Product / Process Change Notification (PCN) ☐ Major change ☐ Minor change		
PCN #:	PCN_WIRL-PRO8_20190801	Change Category:
Affected Series:	WE-WIRL-PRO8; P/N 260702118100x	□ Equipment / Location⊠ General Data□ Material
PCN Date:	July 01, 2019	□ Process
Effective Date:	August 01, 2019	□ Product Design□ Shipping / Packaging□ Supplier□ Software
Contact:	Product Management	Data Sheet Change:
Phone:	+49 (0) 7942 - 945 5001	⊠ Yes □ No
Fax:	+49 (0) 7942 - 945 5179	Attachment:
E-Mail:	pcn.eismart@we-online.com	□ Yes ⊠ No
DESCRIPTION AND PURPOSE OF CHANGE:		
Because of a database mismatch, Würth Elektronik will correct the datasheet.		
All products since market launch, are affected by this change.		
There will be no change in form, fit, function, quality or reliability of the product.

DETAIL OF CHANGE:

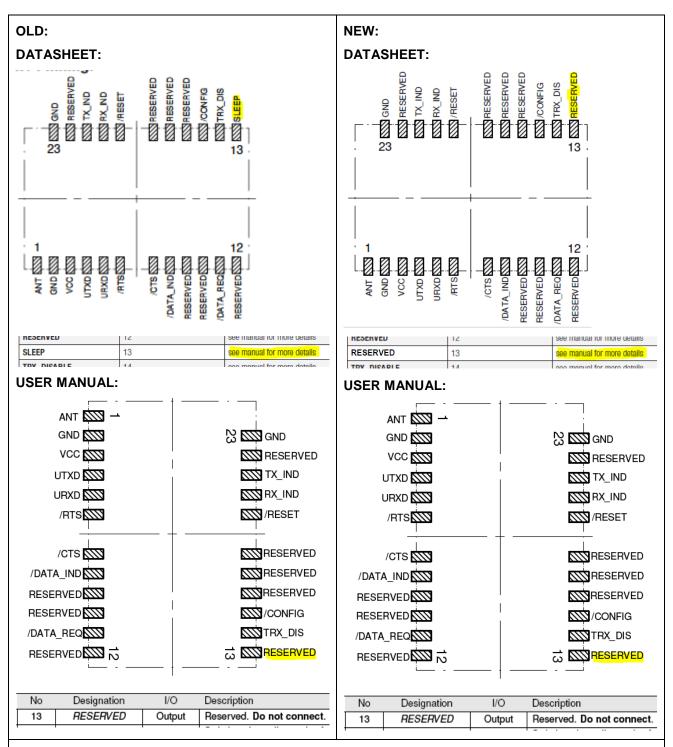
Pin 13 of the module was named as sleep pin but pin 13 is reserved for functions not yet implemented. Through the description in the product manual the pin function was explained correctly.

Even with the correct information in the user manual and the note in the datasheet that the user manual is binding a PCN information is created to explicitly inform customers and avoid errors in the design in phase.
